EO 55-45-6A

5 Jun 69

LIST OF FIELD MODIFICATIONS
SAFETY HARNESS - GENERAL

Figure 1 Locking Tab - MA5 and MA6 Lap Belts

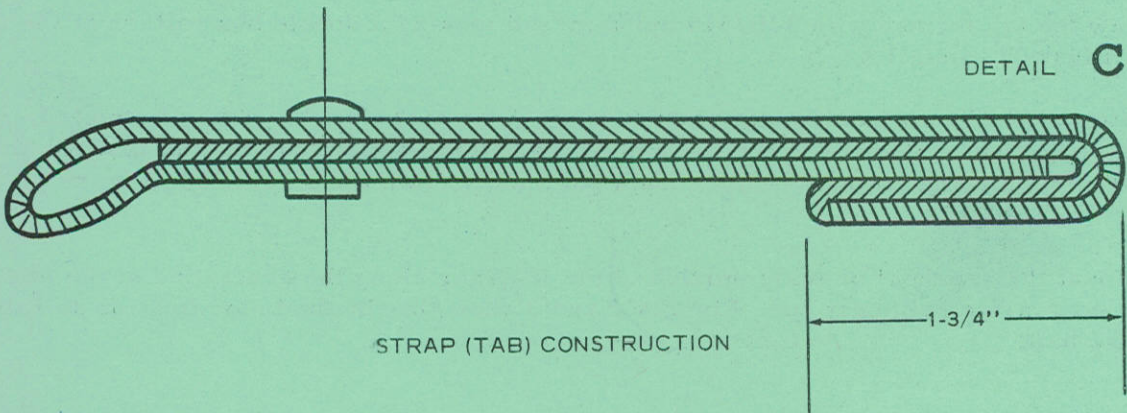
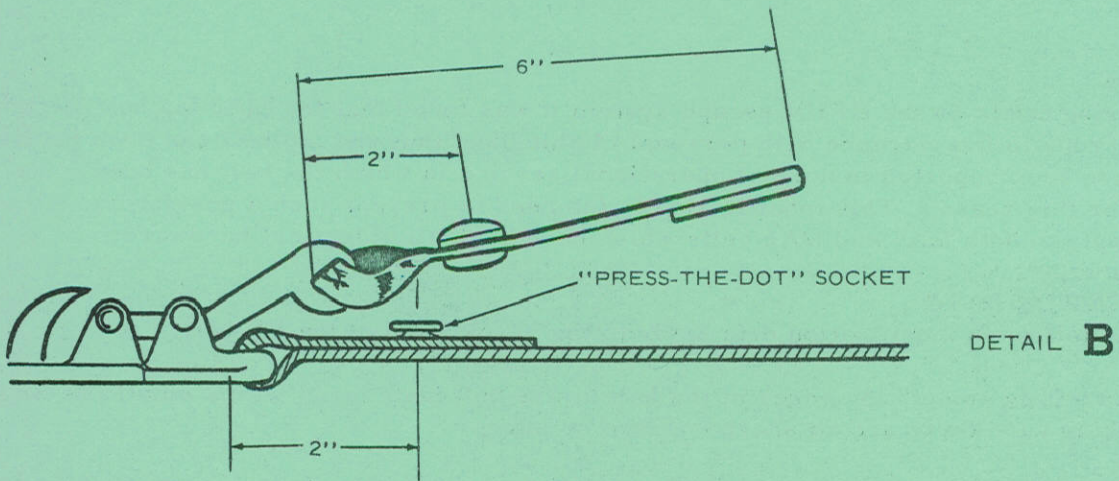
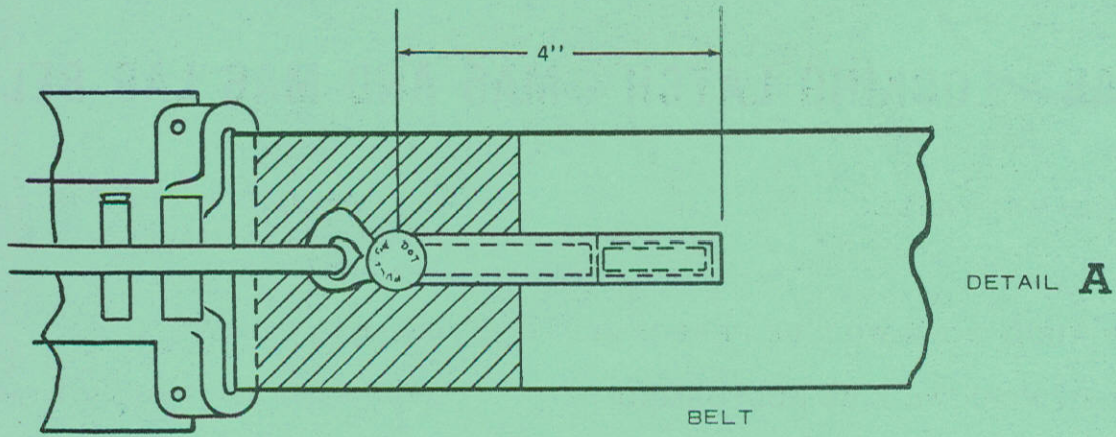
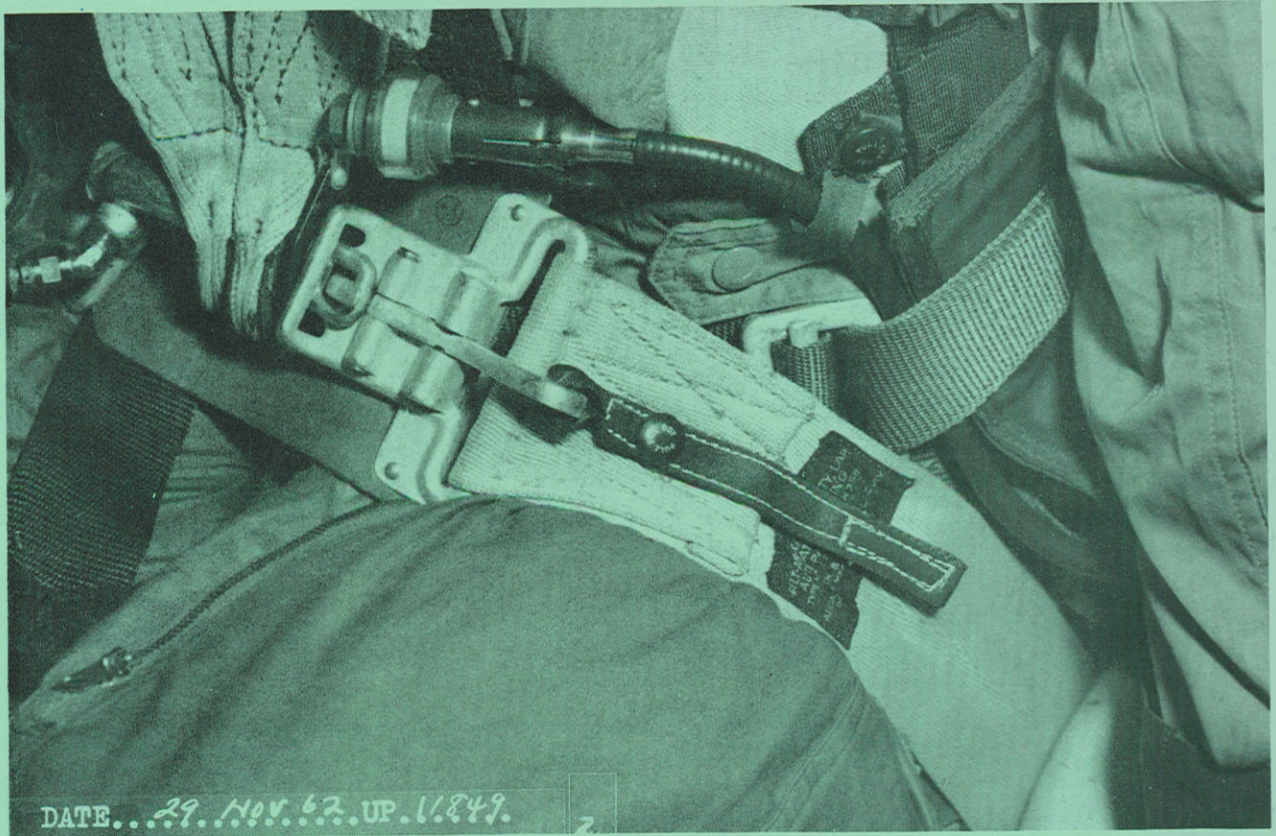
1 During trials on the CF104 escape system it was found that the MA6 lap belt latch hook lever is prone to interference with personal clothing and thus the lap belt can open inadvertently. Cases have been reported in normal operational service in which the belt has been found unlatched for this reason. This modification is intended to prevent such a possibility. All remarks herein apply to both MA5 and MA6 belts which have basically identical hardware.

- (a) Carefully smooth the edges of the hole in the belt hook lever with a small file or emery cloth making sure there are no sharp corners or burrs.
- (b) Cut a 22" length of nylon webbing and insert in the hole in the lever. Fold the webbing as indicated in Figure 1, Detail C.
- (c) Sew the tab formed with 32B/415 nylon thread making a double box pattern at the free end, see Figure 1, Detail A.
- (d) Attach the "button" or female portion of the "press-the-dot" fastener to the tab, 2" from the lever-end. Ensure that the lip on the rim of the button points along the tab towards the lever (if a "dot" is painted on the button this should point away from the lever), see Figure 1, Detail B.
- (e) Mount the "socket" or male portion of the fastener along the centreline of the belt 2" from the hardware attachment end. Figures 2 and 3 show the finished modification as fitted to an MA6 lap belt.

Figure 1

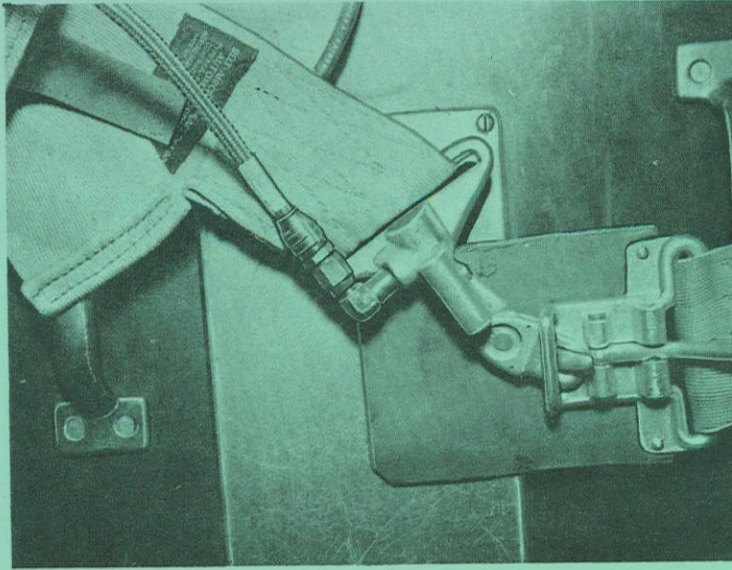
- (a) Ensure that the D ring, D ring safety pin and canopy ejection safety pin are properly installed.
- (b) Disconnect the initiator hose from the lap belt actuator where it connects to the existing 45° elbow. Cap the initiator hose to prevent entry of dirt or foreign material.
- (c) Remove the lap belt from ejection seat.
- (d) Remove existing 45° elbow fitting from the actuating mechanism.
- (e) Install new Parker 90° elbow Ref 15E/4730-00-666-4320.
- (f) After installing 90° elbow, harness is to be tested as outlined in paragraphs 12, 13 and 14 of EO 55-45-2, Part 2, Section 1.
- (g) The initiator hose should fit snugly against the lap belt as shown in Figure 1.
- (h) Re-install lap belt on ejection seat.

Figure 1 C2 Seat Lap-Belt Extension Tab

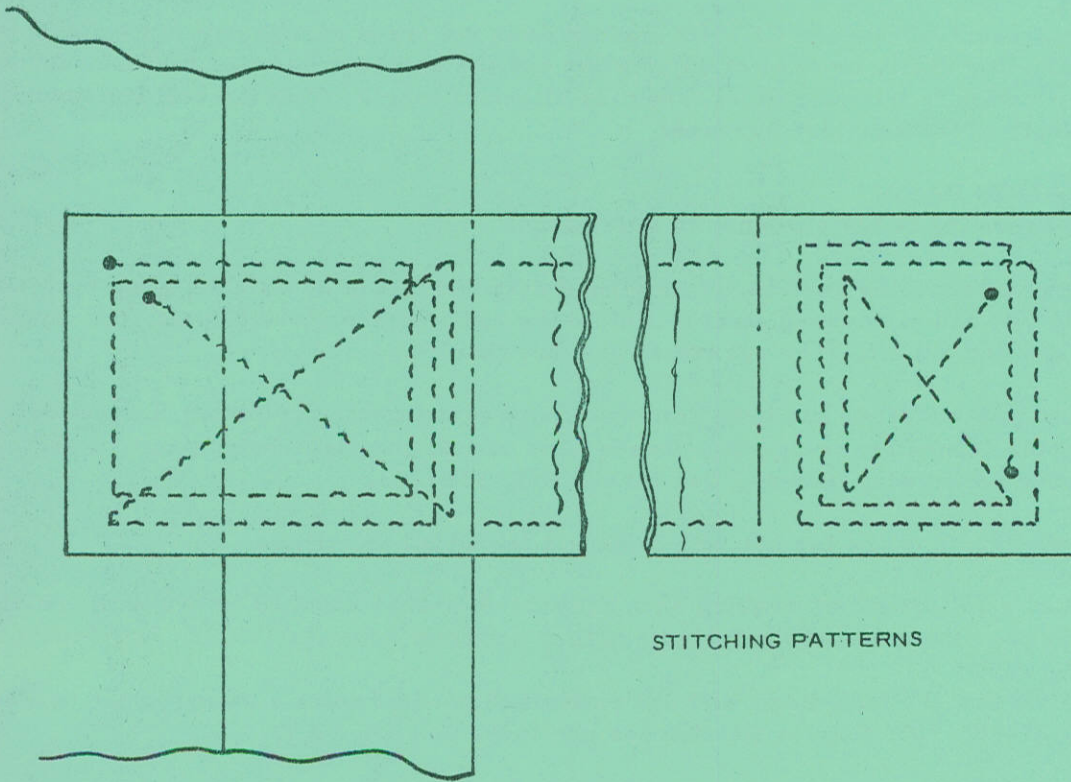
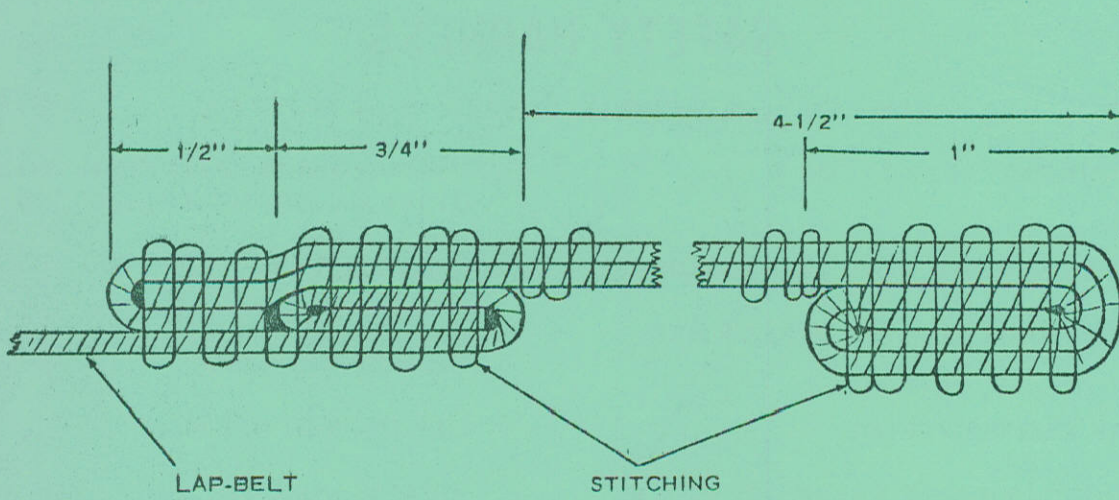
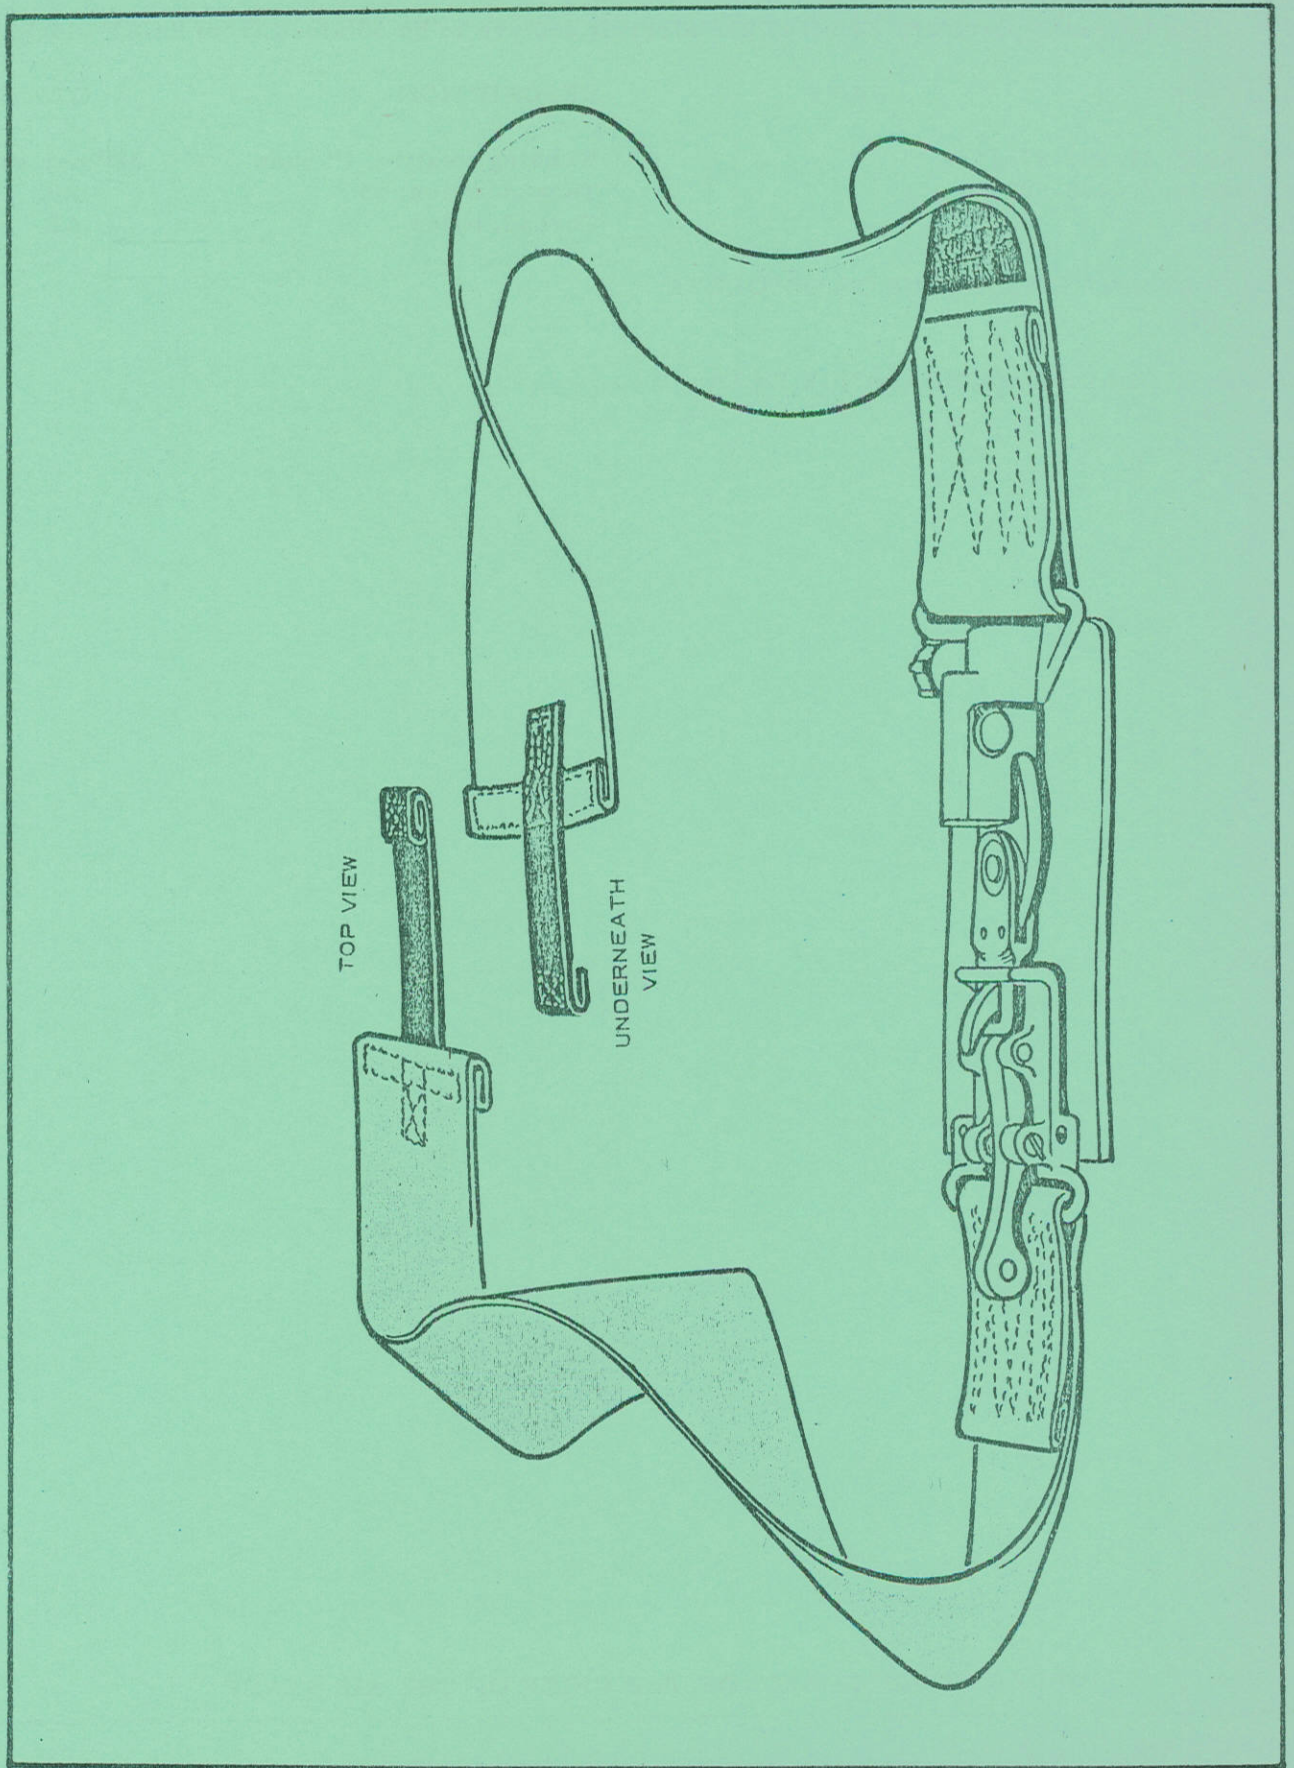
- (c) Both halves of the lap belt are to have a tab added as follows:
 - (1) Cut a 16" length of webbing 32B/8305-21-804-4761 and fold in two with one side 1/2" longer than the other. Using the folded end tuck under in a double 1" fold, see Figure 1.

- (2) Oversew the folded end with the pattern shown in Figure 1 using thread nylon Ref. 32B/8310-21-806-5032 four to six stitches per inch, see Figure 1.

- (3) Take the free ends of the tab, tuck the 1/2" portion around and under the shorter end of the webbing. Sew to the lap belt as shown in Figure 1.
 - (4) Sew tabs along both sides so that both parts of the tab webbing will be attached to each other, see Figure 2.

Figure 1

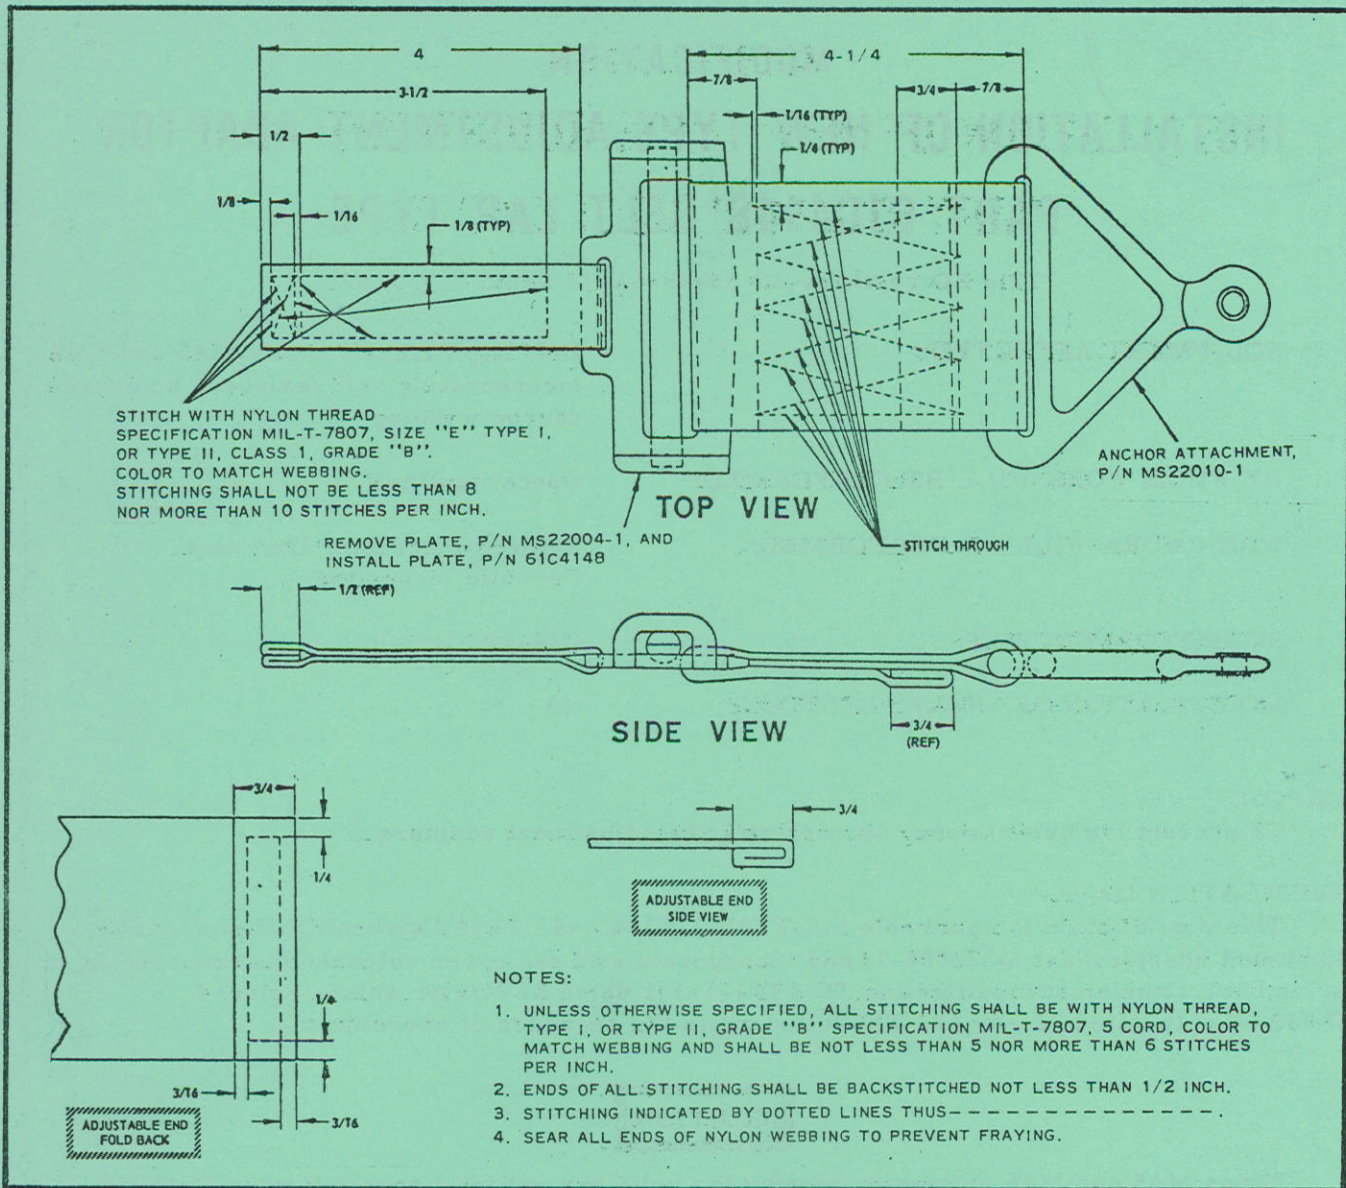
- (1) Slide one end of the adjuster release tab through adjuster release tab slot in new adjuster plate Part 61C4148.
 - (2) Join the two ends of the adjuster release tab, fold in 1/2" of the adjuster release tab end and stitch through. See Figure 1 for fold-in and stitch-through instructions.

- (3) Slide the 3/4" folded-in webbing end of the seat anchor attachment webbing through the adjuster plate Part 61C4148. See Figure 1 for installation reference.

- (4) Join the 3/4" folded-in webbing end with the other two webbing folds of the seat anchor attachment and stitch through. See Figure 1 for stitching instructions.

- (5) Re-install adjustment end through adjuster plate Part 61C4148, in reverse of procedure outlined for removal.
 - (6) If adjustment end stitching was cut and removed in accordance with instructions contained in paragraph 2(c)(1), fold in the webbing end approximately 3/4" and stitch through. See Figure 1 for fold-in and stitching instructions.

Figure 1

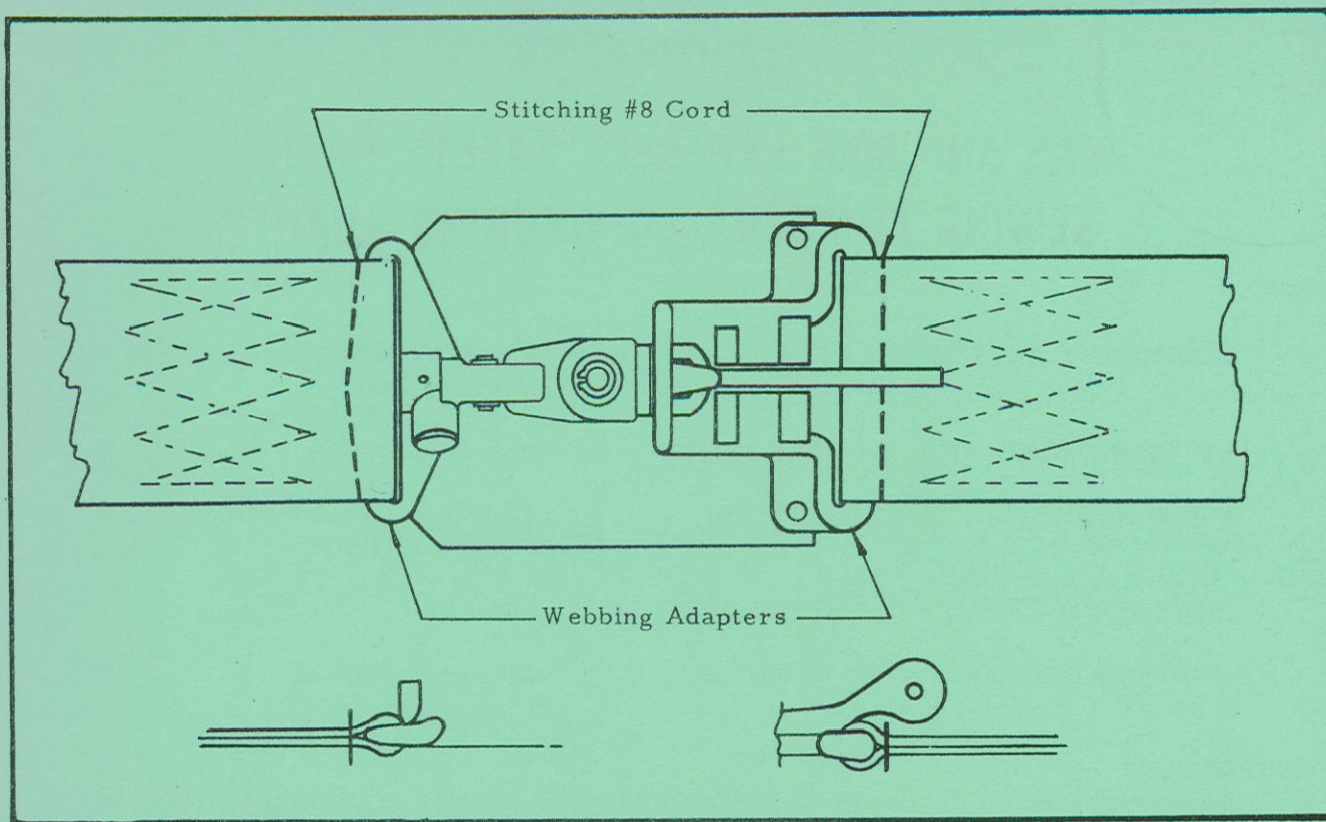
- (a) It has been reported that the soft green dacron webbing does not support the latching mechanism in the correct position. This condition is caused by the soft green dacron webbing sliding to the side of the webbing adapter, where it gathers, coils and twists the latching mechanism. The coiled webbing fails to give the protection of the wide belt and on ejection the automatic release may fail to function, when the latching mechanism is not supported as required.

- (b) To prevent the webbing from slipping all MA5 and MA6 lap belts incorporating the soft green dacron webbing are to be modified by adding a row of stitching as close as possible to the webbing adapters on the latch assembly, see Figure 1.

- (c) The sewing is to be done using Ref. 32B/388 linen cord #8 waxed, as follows:
 - (1) Use two needles one on each end of the linen cord.
 - (2) Start the stitching approximately 1/8 of an inch from one side. Pass the first needle down through both thicknesses of webbing and draw the #8 cord through approximately half its length. Ensure that sufficient cord is used to complete the sewing. Next, sewing 4 stitches to the inch, pass one needle up and one needle down through the same holes. Stitches are to be pulled tight to add a stiffening effect. Sew across the entire width of the lap belt.
